ADDENDUM TO RFP

Redwood Coast Energy Authority
Fence Installation for ACV Microgrid

Addendum #2
June 17, 2020

AOA FENCING PLAN

C-202

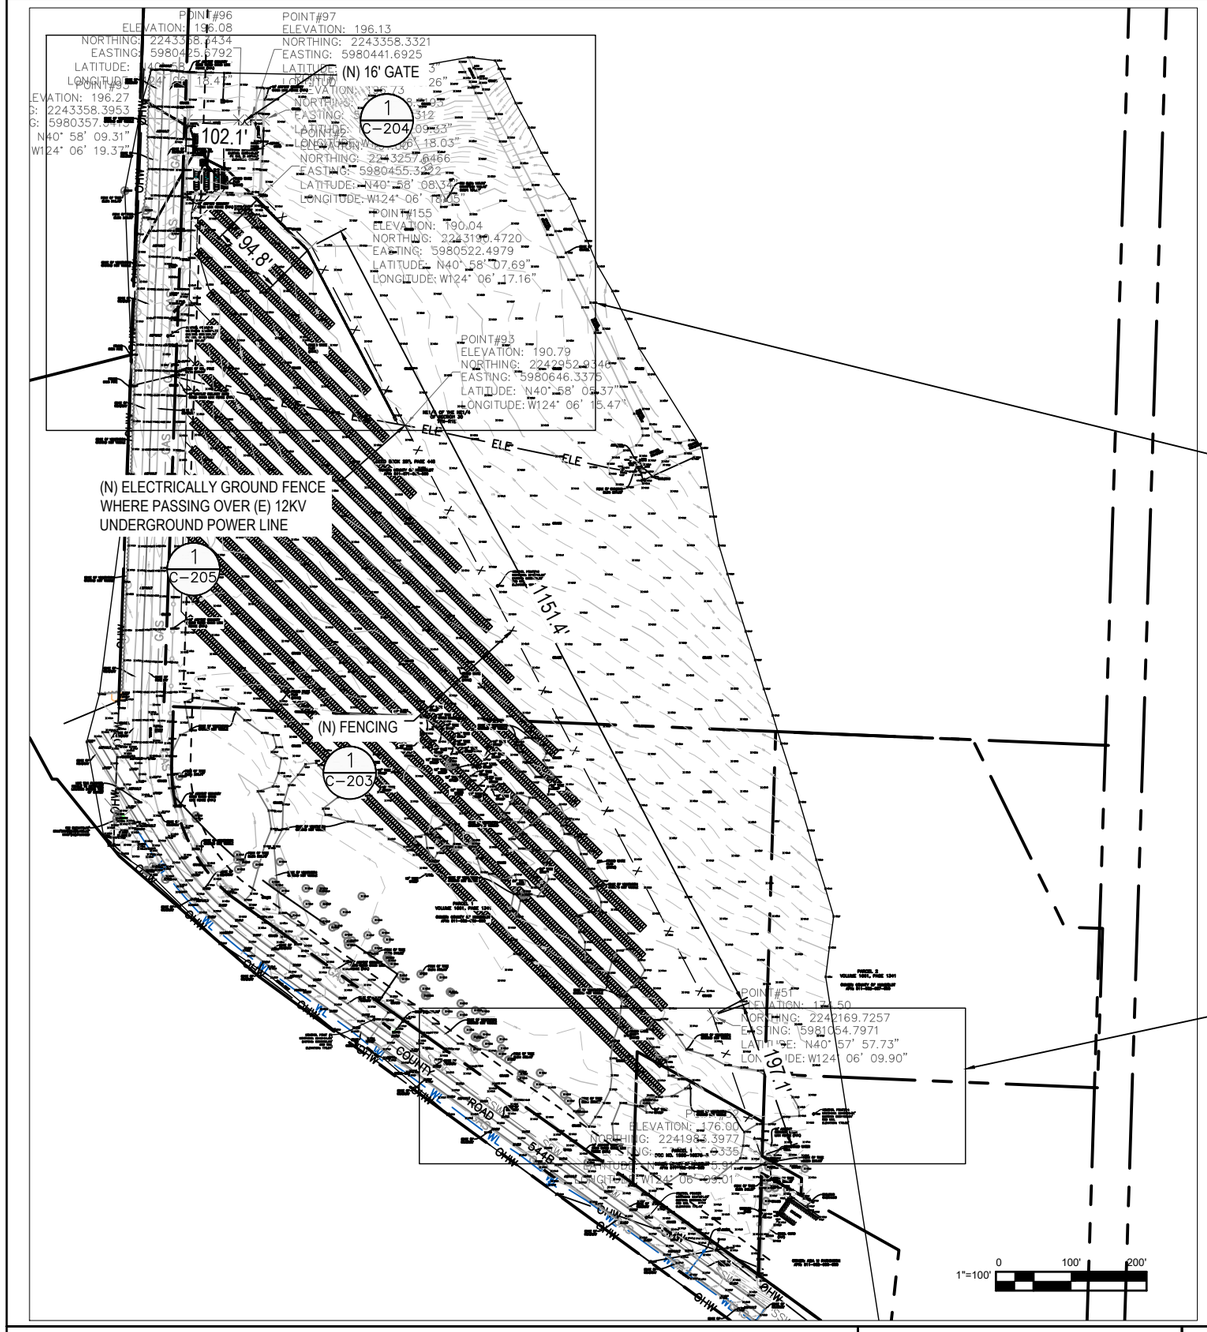
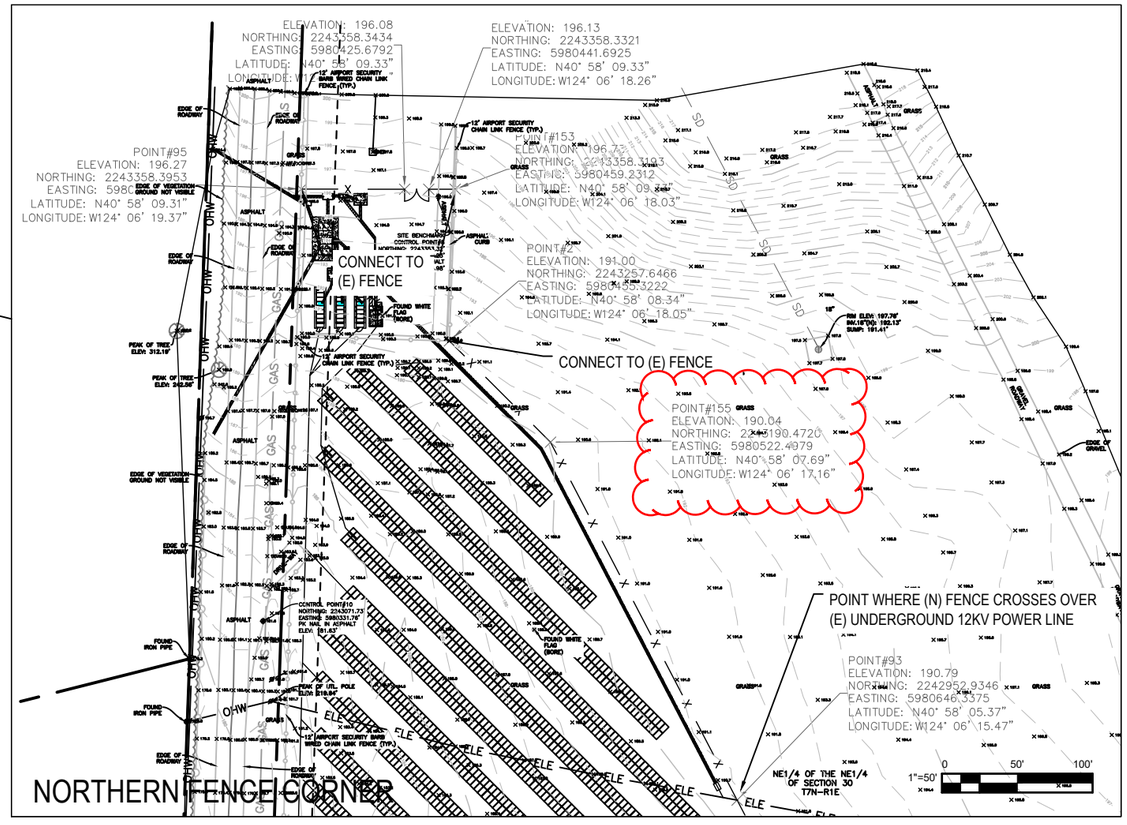
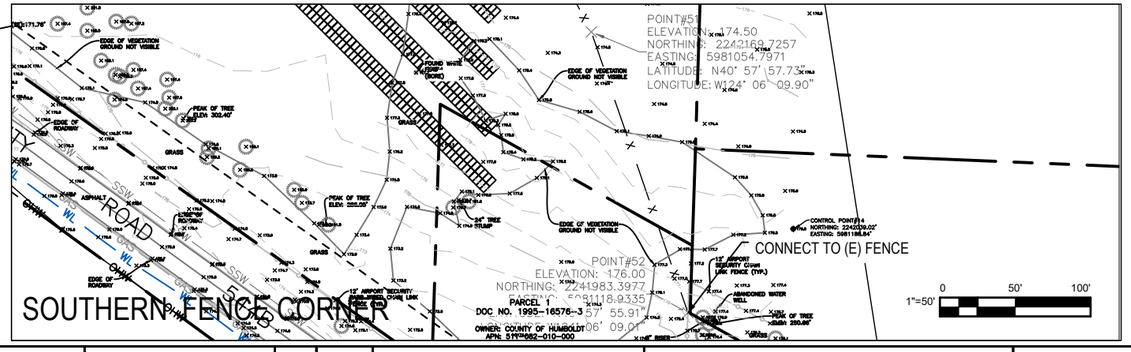
Question 4: Who will be responsible for the surveyor staking for the location of the fence line? Can you please be sure to provide all the coordinates for fence line?

Answer: The contractor will be responsible for the surveying for the location of the fence line. Please see attached revised plan with all necessary coordinates.
